NOTICE OF PROPOSED CHANGE IN PROPERTY

Petition: x762

REQUEST TO OUTRIGHT VACATE
 THE NORTH/SOUTH PUBLIC ALLEY, 14 FT. WD.
 IN THE BLOCK BOUND BY
 ASH AND ELM ST., HARRISON AVE.
 AND ROSA PARKS BLVD.

CITY OF DETROIT	
CITY ENGINEERING DEPARTMENT	
SURVEY BUREAU	
JOB NO.	01-01
DRWG. NO.	X 762

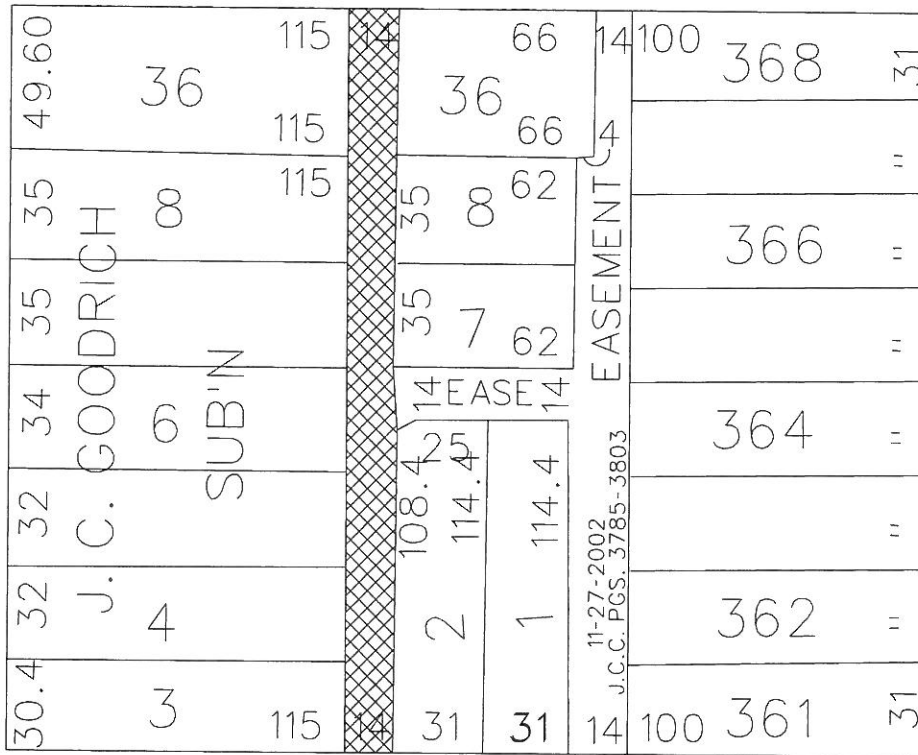
Involved; but asking you to hold action on this petition until further notice.

There exist DTE power supply in the alley which provide power to street lights. Consider Easement than Vacation.
